Amendments to the Drawings:

REMARKS/ARGUMENTS

The present amendment is submitted in response to the Office Action dated May 11, 2009, which set a three-month period for response, making this amendment due by August 11, 2009.

Fig. 2

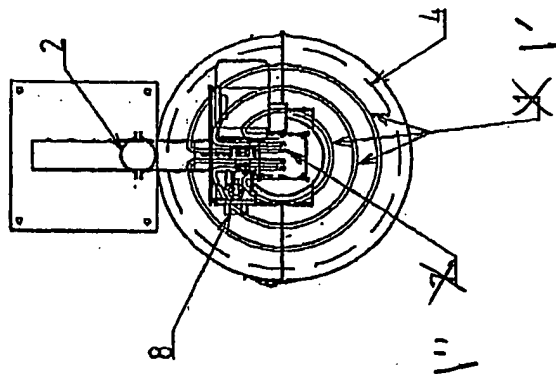
The attached sheet of drawings includes changes to Figs. 1a, 1b, and 2. On the attached drawing sheet Figs. 1a and 1b have been modified only to include the words "Thermal Sensor" to reference numerals 5 and 7. In addition, Fig. 2 has also been changed so that reference numeral 1", rather than 7, now refers to the "junction spoke". Also in Fig. 2, reference numeral 1', rather than 1, now designates the "concentric rings".

Turning first to the objection to the drawings, filed herewith are amended Figs. 1a, 1b and 2. In Figs. 1 and 1b, the label "thermal sensor" has been added with reference numerals 5 and 7, as requested by the Examiner. Reference numeral 1, rather than "7", has been added to Fig. 2 to refer to the "junction spoke". Reference numeral 1', rather than "1", now designated the "concentric rings".
